ADDENDUM NO.: ONE (Rio Vista Elementary)

PROJECT: BID #1940 Modernization of Three Elementary School Campuses, Phase 1

ADDENDUM NO. 1

Project:	Mt Diablo Unified School District **Rio Vista Elementary School** **Increment 1**	
19six #:	23118	
DSA #:	01-121440	File #:7-29
Bid #:	###	
Date:	April 16, 2024

SITE PLAN - ACCESSIBILITY - FIRE AUTHORITY | 1" = 30'-0" | 1

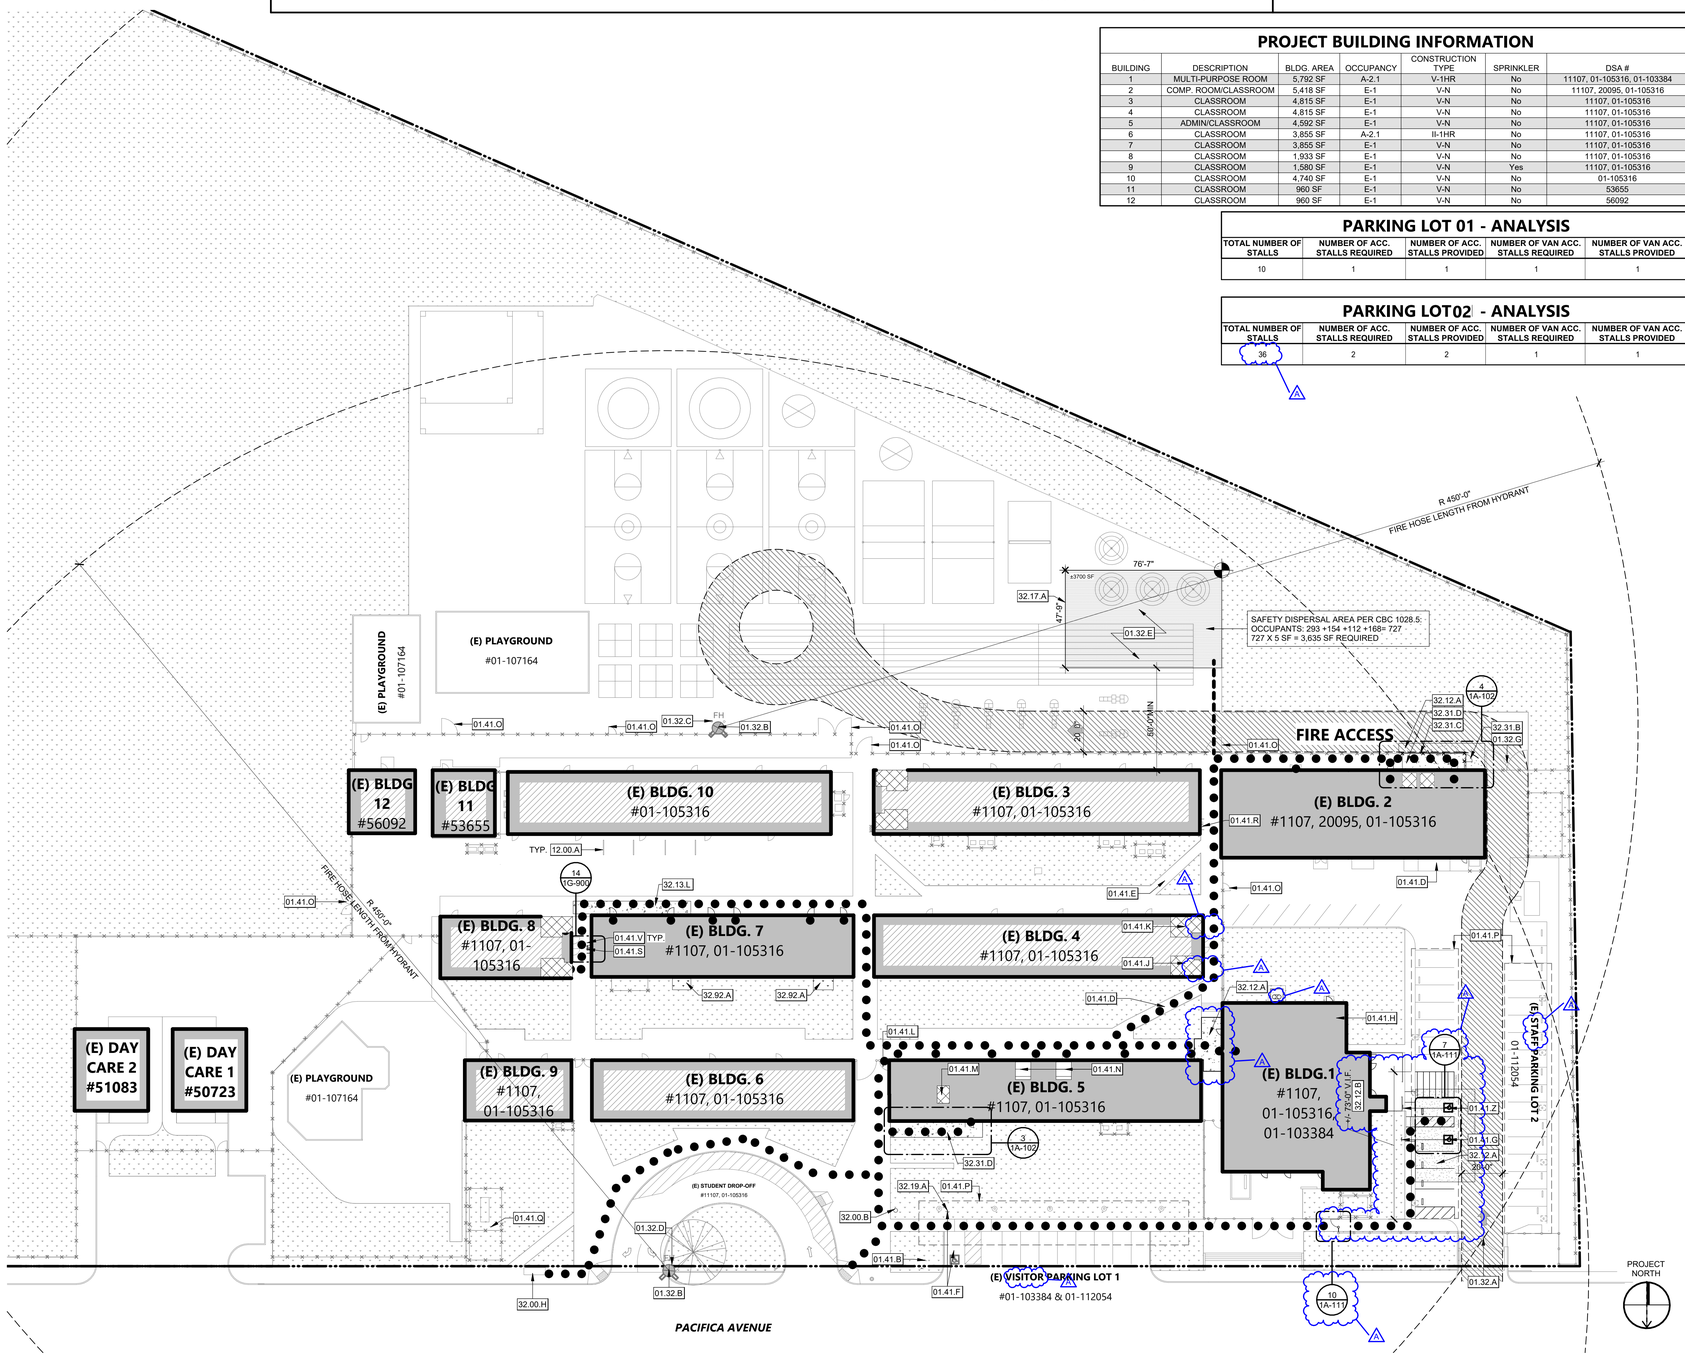
ITEM 2. 1G-101 - FIRE AUTHORITY SITE PLAN

- Added Keynote 01.41.Z (N) ACCESSIBLE PARKING STALL. INSTALL NEW SIGNAGE AT THE EXISTING WOODEN FENCE.
- Added Keynote 32.00.B EXISTING LIGHT POLE. PROTECT DURING CONSTRUCTION.
- Revised Keynote 32.31.D.
- Added Concrete Paving Hatch to Legend.
- Clarified Sand Hatch on Legend as Asphalt Paving, per Civil.
- Updated Parking Stall count for Parking Lot 2.
- Clarified Parking Lot 1 is Visitor Parking.
- Clarified Parking Lot 2 is Staff Parking.
- Made slight Adjustments to Path of Travel.

- Made slight Clarifications to Site Plan for Consistency with later sheets.
- Added View References to Details later in the set.

BLDG. 1 FLOOR PLAN DEMO | 1/8" = 1'-0" | 1

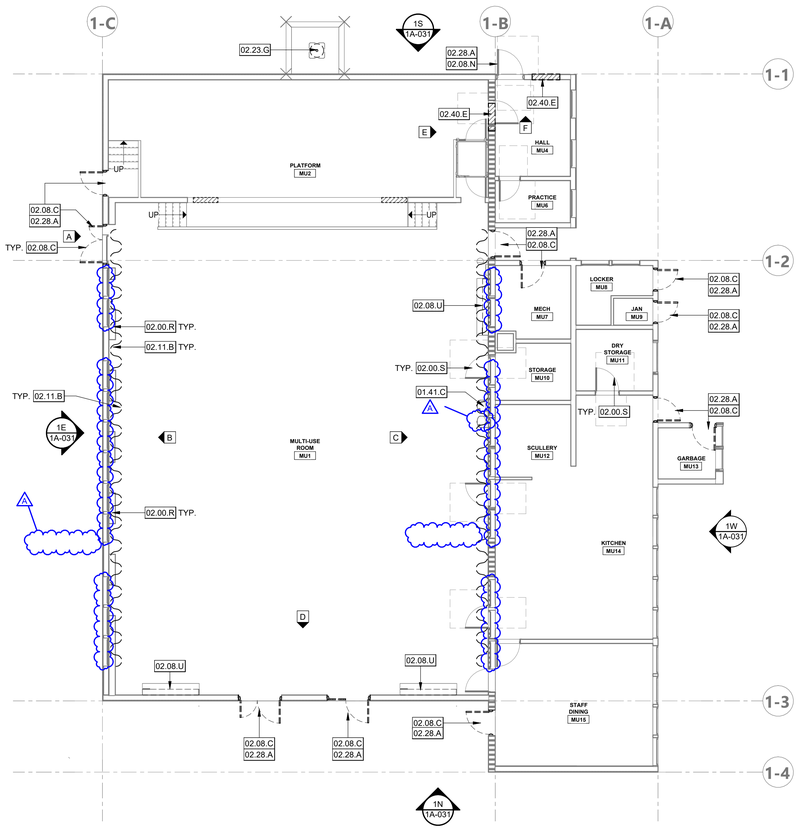
ITEM 6. 1A-021 - BLDG 1&2 -DEMO FLOOR PLAN

- Building 1 Demolition Floor Plan:
  - Removed Keynote 02.08.A.
  - Clearstory Windows in MPR are No longer being Demolished and are to remain.
- Building 2 Demolition Floor Plan:
  - Added Gridlines to Mechanical Mezzanine plan.
  - Revised Mechanical Mezzanine plan to indicate entire mezzanine is now to be demolished.

BLDG. 5 DEMOLITION RCP | 1/8" = 1'-0" | **1**

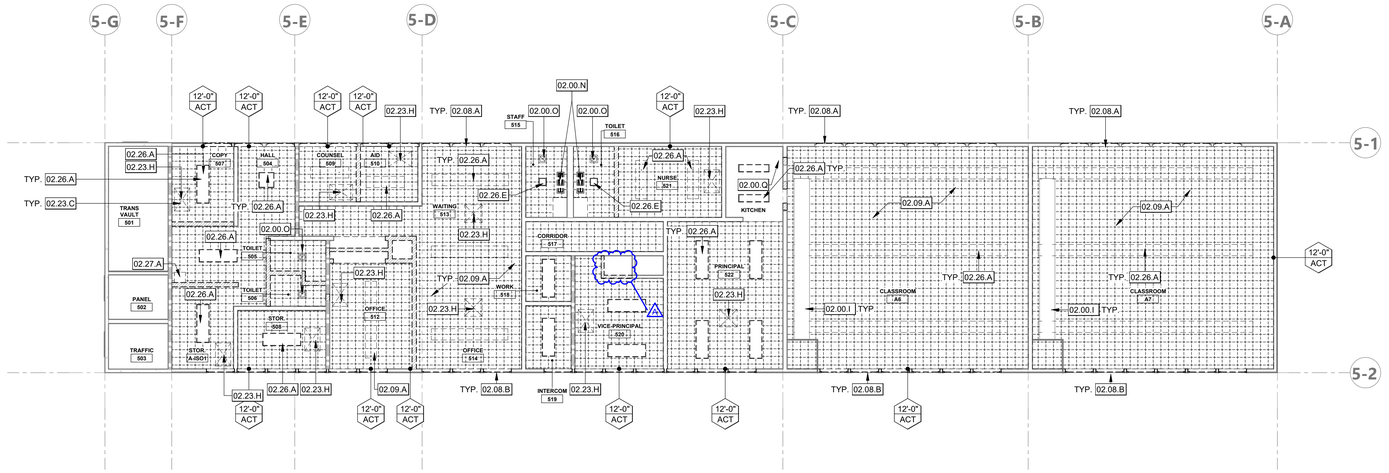
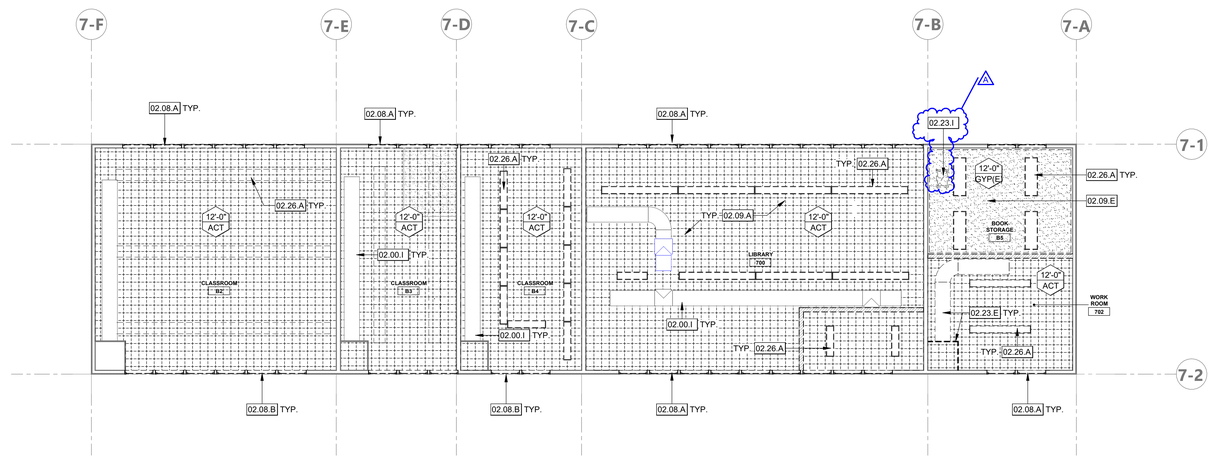
ITEM 9. 1A-024 - BLDG 5&7 -DEMO REFLECTED CEILING PLAN

- Building 5 Demolition RCP:
  - Added demolition of Closet from Vice Principal's office.
- Building 7 Demolition RCP:
  - Added Existing mechanical return register to Room B5, to be demolished.

BLDG. 1 FLOOR PLAN | 1/8" = 1'-0" | 1

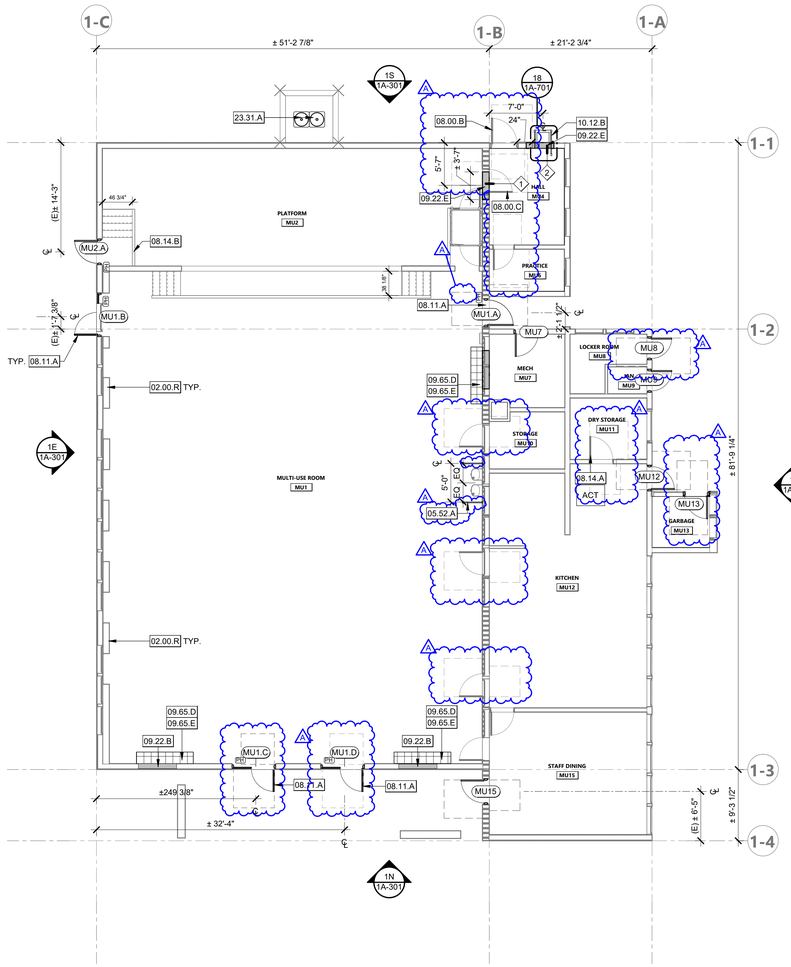
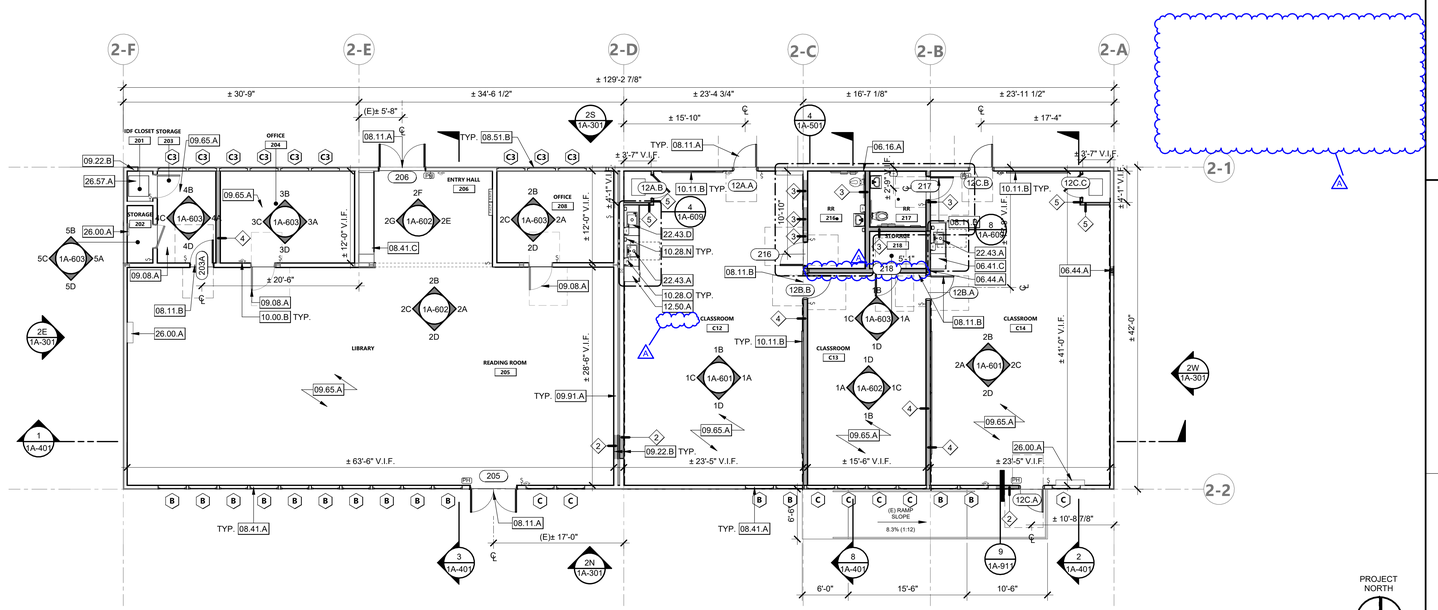
ITEM 14. 1A-201 - BLDG 1&2 -FLOOR PLAN

- Added Keynote 08.00.C (E) DOOR AND FRAME TO REMAIN.
- Revised Keynotes 09.22.E, 22.43.A, and 22.43.D.
- Added Floor Plan General Note #7.
- Building 1 Floor Plan:
  - Added ADA Door Clearances to some Doors.
  - Removed Door Actuator.
- Building 2 Floor Plan:
  - Removed Mechanical Mezzanine.
  - Adjusted Infill Wall and Door swing in Rooms C13 and 218.

BLDG. 5 FLOOR PLAN | 1/8" = 1'-0" | 1

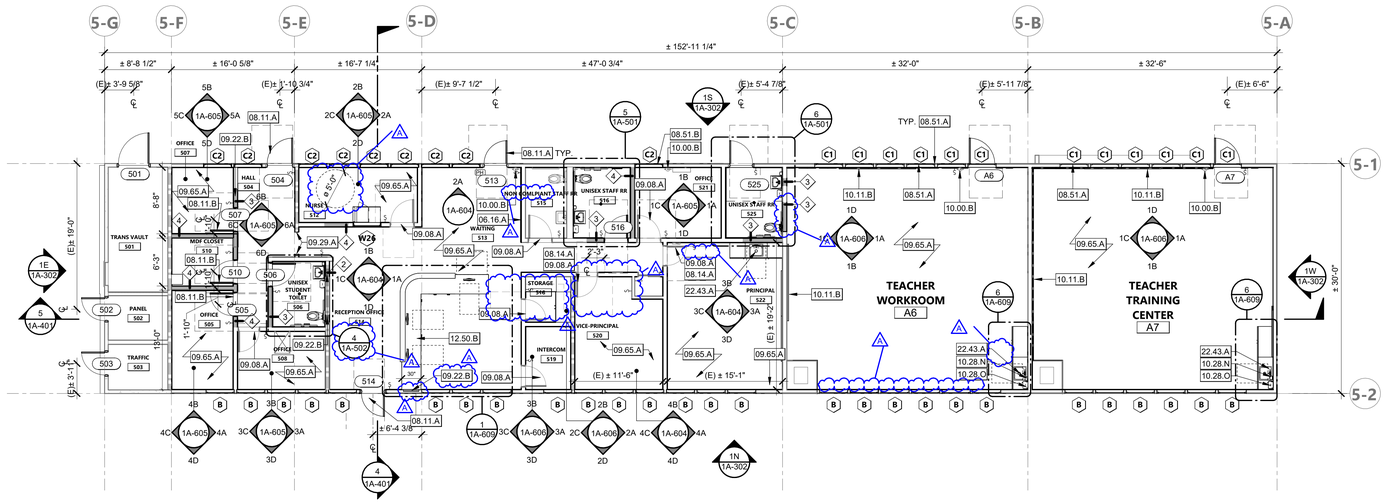
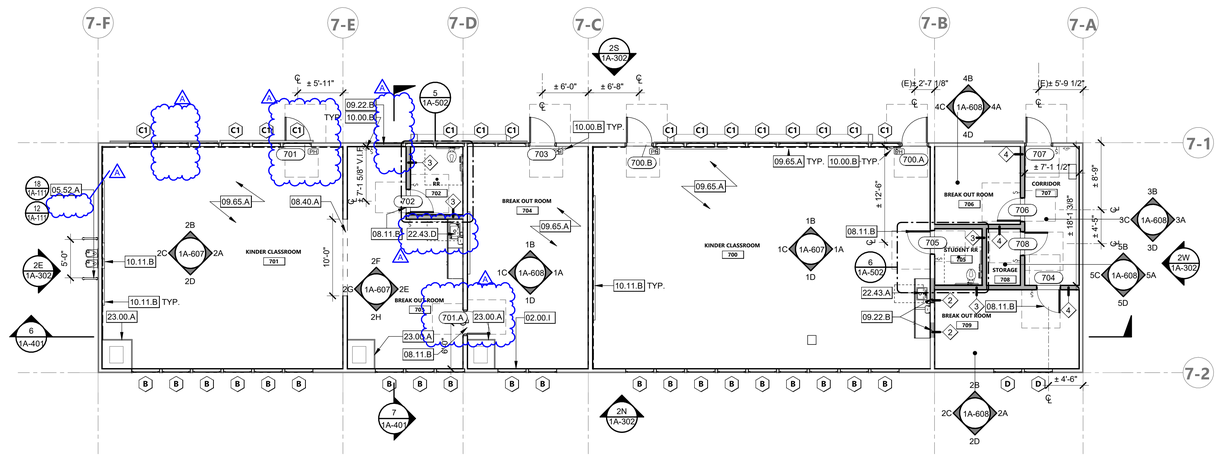
ITEM 15. 1A-202 - BLDG 5&7 -FLOOR PLAN

- Revised Keynote 22.43.D.
- Building 5 Floor Plan:
  - Removed Casework from Room A6.
  - Removed Closet from Vice Principal's Office.
  - Indicated that Staff Restroom Room 515 is Non-Compliant with ADA Requirements for Accessibility.
  - Added ADA Door and Turning Clearances to Doors and Select Rooms.
  - Added View Reference for Room 506.

- Added Wall Patch where New Reception Desk meets Wall.
- Removed Door Actuator from Principal's Office.

- Building 7 Floor Plan:
  - Changed the Locations of New Doors in Room 701 and 703.
  - Added ADA Door and Sink Clearances.

BLDG. 1 ROOF PLAN 1/8" = 1'-0" **1**

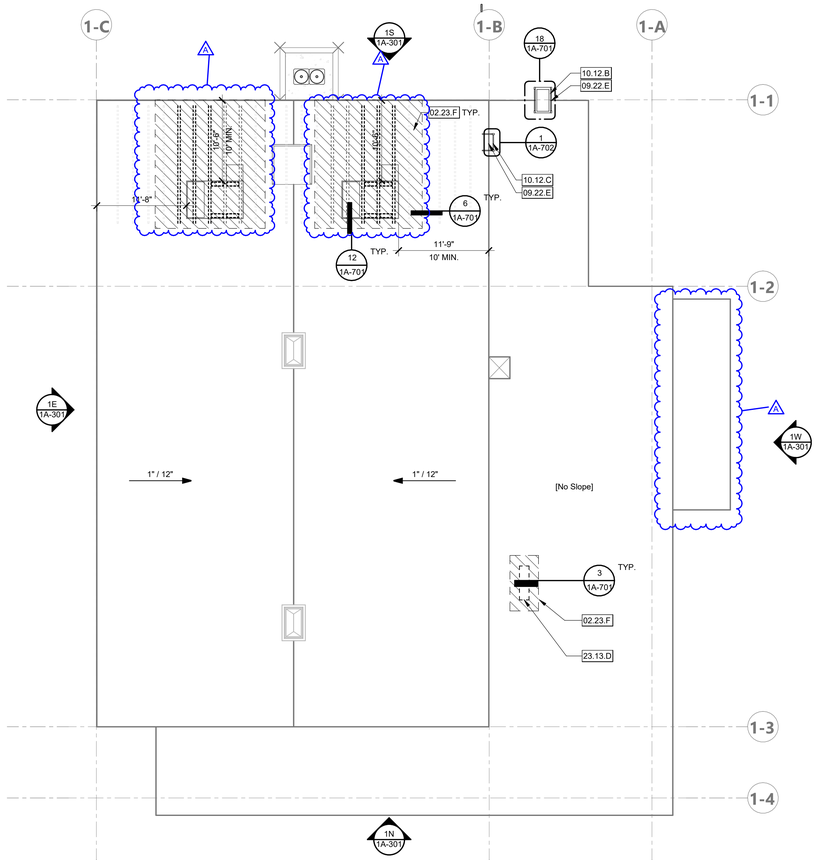
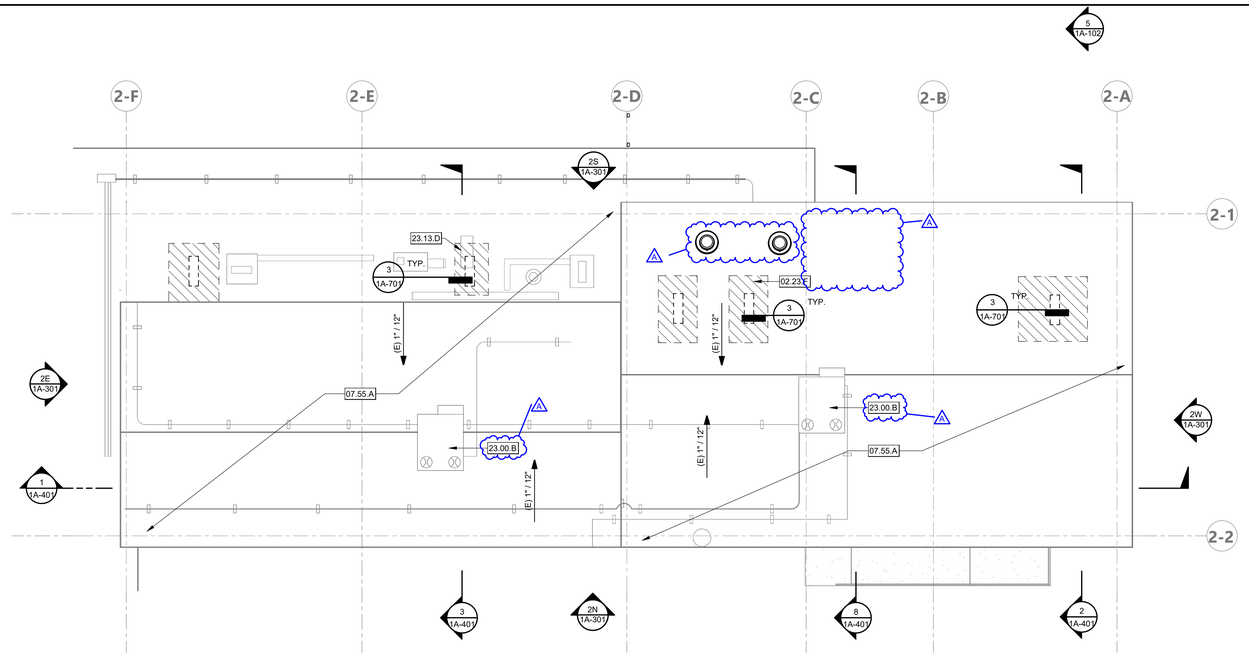
ITEM 16. 1A-205 - BLDG 1&2 -ROOF PLAN

- Removed Keynotes 10.00.B and 23.13.B.
- Added Keynote 23.00.B (E) MECHANICAL UNIT. NO NEW WORK.
- Building 1 Roof Plan:
  - Revised extents of Roof Demolition
  - Showed Existing lower roof Canopy, not new work.
- Building 2 Roof Plan:
  - Removed Split Heat Pump and Associated work.
  - Added 2 Exhaust Fans, see Mechanical Drawings for more Details.
  - Clarified Existing Mechanical Equipment to remain.

BLDG. 5 ROOF PLAN | 1/8" = 1'-0" | **1**

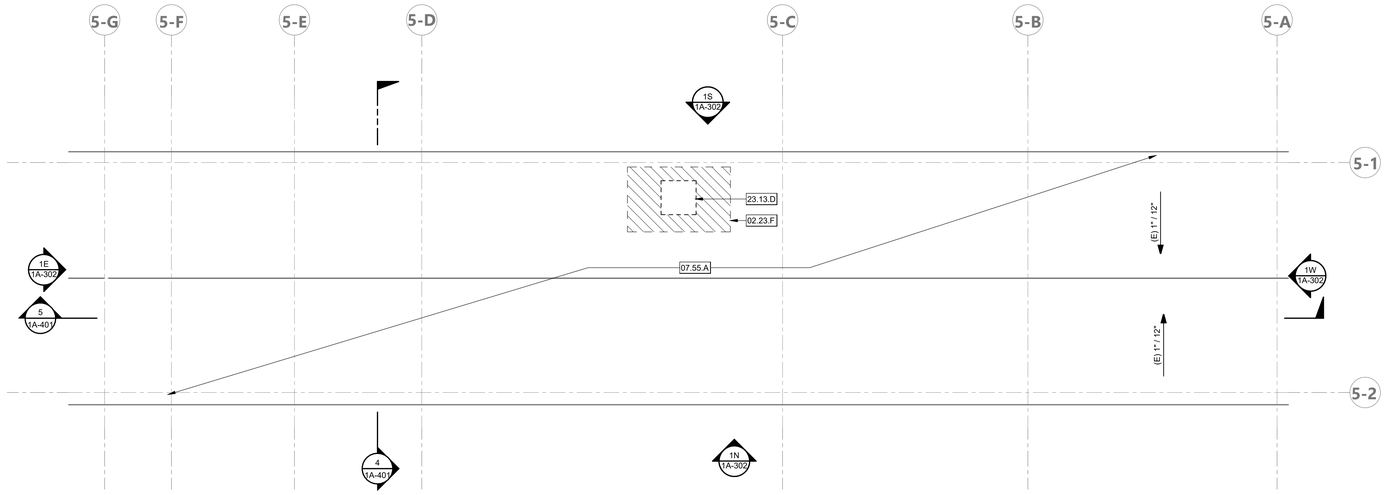
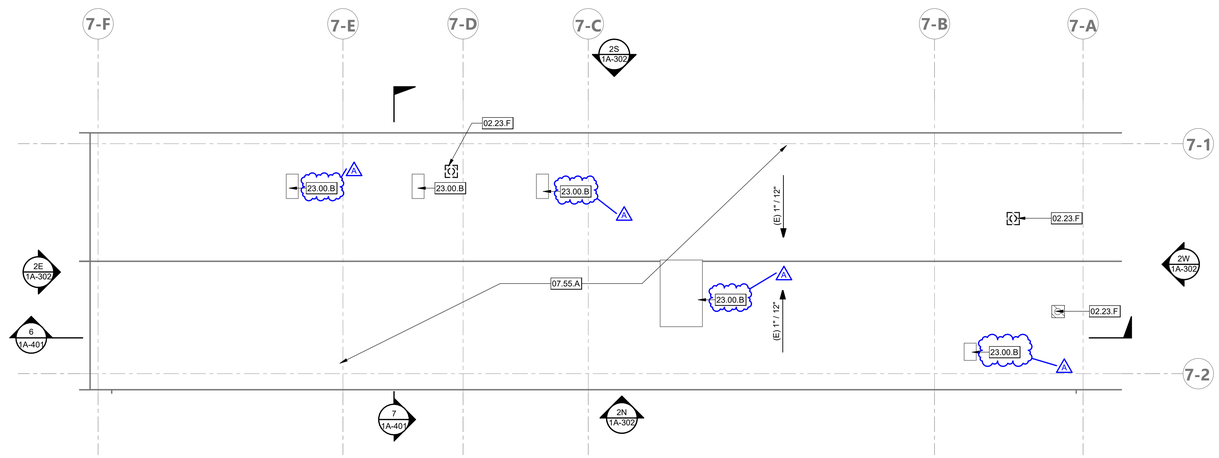
ITEM 17. 1A-206 - BLDG 5&7 -ROOF PLAN

- Added Keynote 23.00.B (E) MECHANICAL UNIT. NO NEW WORK.
- Building 7 Roof Plan:
  - Clarified Existing Mechanical Equipment to remain.
